STAFF PAPER

Review of San Francisco Public Utilities Commission's Integrated Resource Plan Filing

June 2019 | CEC-200-2019-007

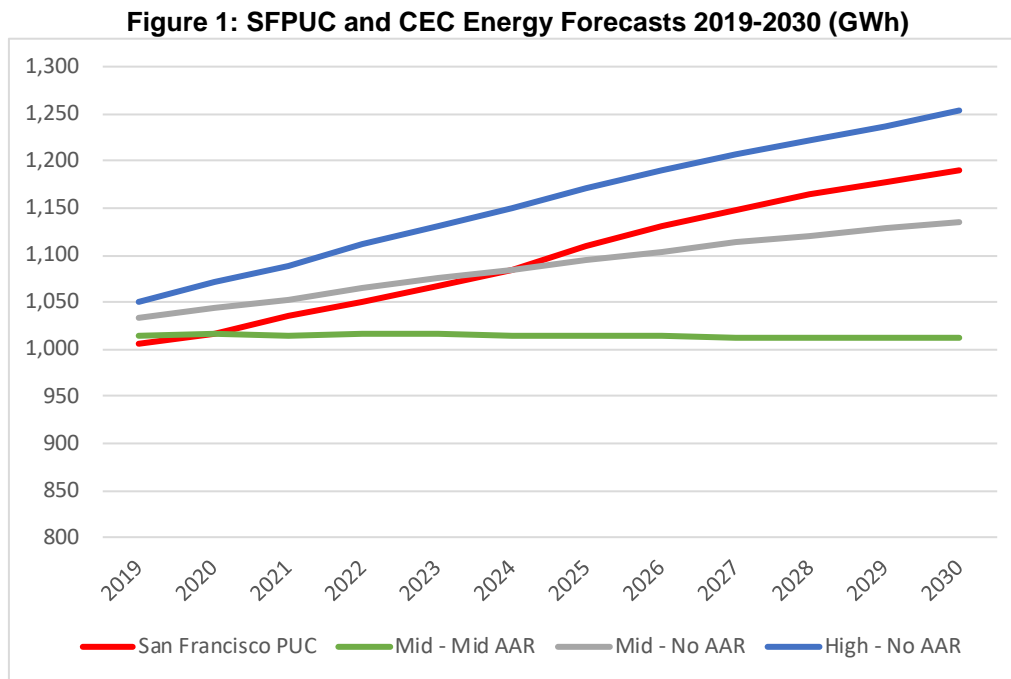
Figure 1 compares the SFPUC’s 2017 IRP baseline energy demand forecast for 2019 to 2030 to forecasts adopted by the CEC as part of the *2017 Integrated Energy Policy Report (IEPR)*.

The SFPUC projected annual growth over 2019 to 2030 of slightly more than 1.5 percent, while the CEC’s “mid demand, mid additional achievable resources” forecast shows no growth.⁹ The annual growth rate projected by the SFPUC is comparable to the CEC’s “high demand, no additional achievable resources” scenario of 1.6 percent.

The CEC’s forecasts of the SFPUC’s energy demand growth, because of its small size (less than a 200-MW peak demand), are based on a growth rate for the Pacific Gas and Electric (PG&E) planning area, which is driven largely by assumptions regarding demographics and the economy. Most of the SFPUC retail sales are to municipal departments, whose demand is less influenced by changes in economic conditions and demographics than are residential, commercial, and industrial consumption. Consequently, the utility used information from the city’s long-term capital planning process to forecast demand growth arising from “new” municipal customers. Capital investments on the part of the city that increase its energy needs place less emphasis on

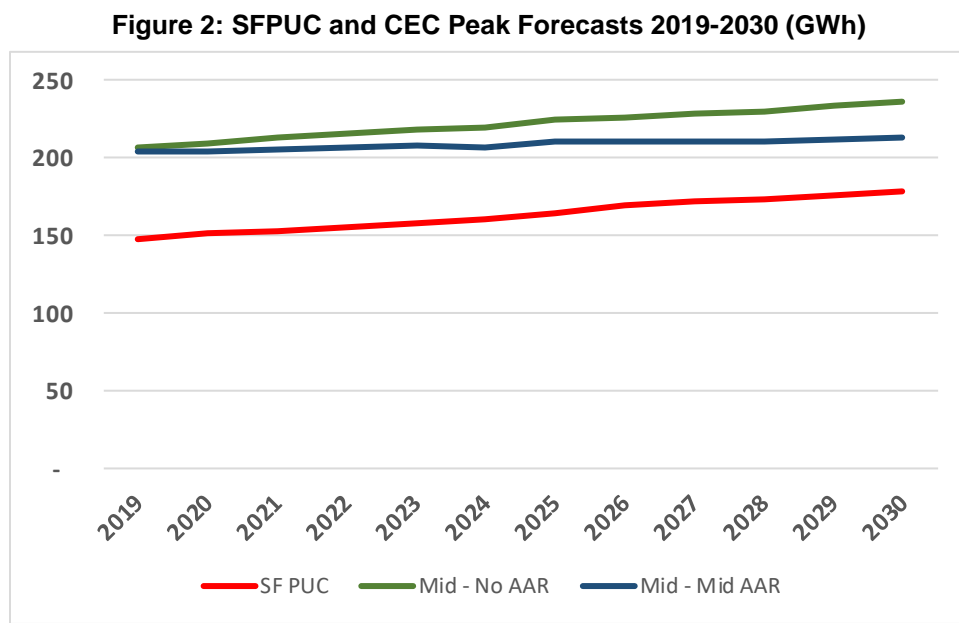
A comparison of the peak demand forecast in the IRP filing to the 2017 IEPR forecasts is in Figure 2.

The CEC's forecasts are well above that of the SFPUC's forecasts. The difference in peak forecasts may be attributable to how the PG&E planning area forecast is shared with the SFPUC forecast. The CEC indirectly forecasts the SFPUC peak demand by apportioning a share of the PG&E planning area peak forecast to the SFPUC service territory.
